# **REBUTTAL TESTIMONY**

# CLAIRE M. EUBANKS, PE

# **GRAIN BELT EXPRESS, LLC**

# CASE NO. EA-2023-0017

Table 6: Incremental Value of Pro	ject Transfer Capabilities	During Recent Storm Events
-----------------------------------	----------------------------	----------------------------

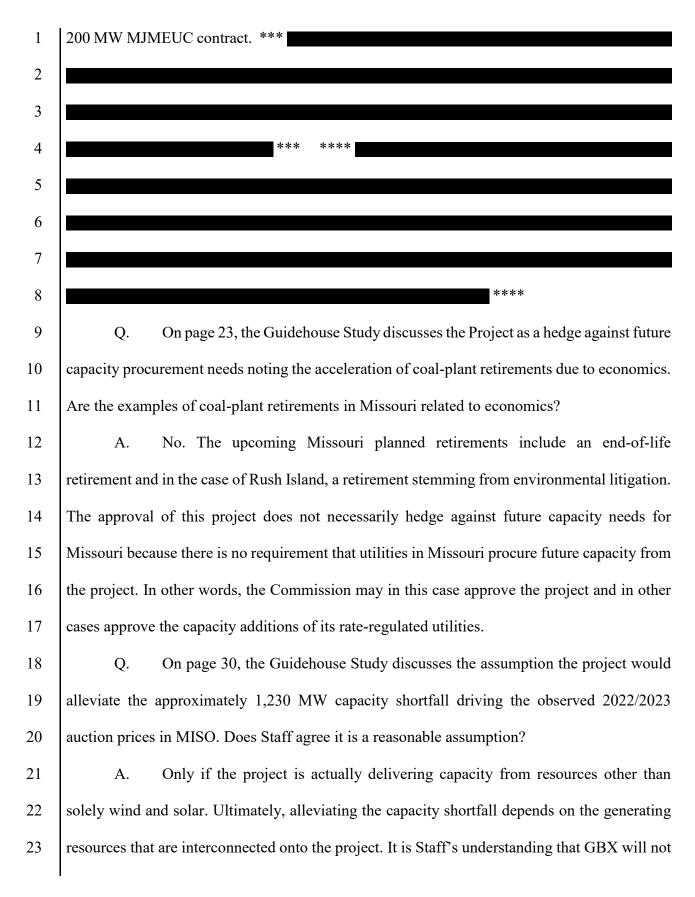
Q. Does Staff agree with the savings presented in table 5 above?				
A. No. Staff is concerned that scenarios presented above assume the project will be				
operated bi-directionally. For example, multiple scenarios are assuming withdraws from MISO				
yet MISO has stated:				
Invenergy's proposal in MISO is centered on Injection Rights and is for the unidirectional flow only. Essentially, Invenergy has only requested to operate the GBX Line as a long generator lead line. <sup>11</sup>				
In other words, GBE, a wholly-owned subsidiary of Invenergy Transmission LLC				
("Invenergy"), has assumed bidirectional flows throughout its application and that assumption				
has been carried through to the Guidehouse study but is inconsistent to its requests to MISO.				
Without the capability for bidirectional flows, the values relied on are overstated and thus				
over-inflates the potential savings. Further, GBE states in response to Staff Data Request
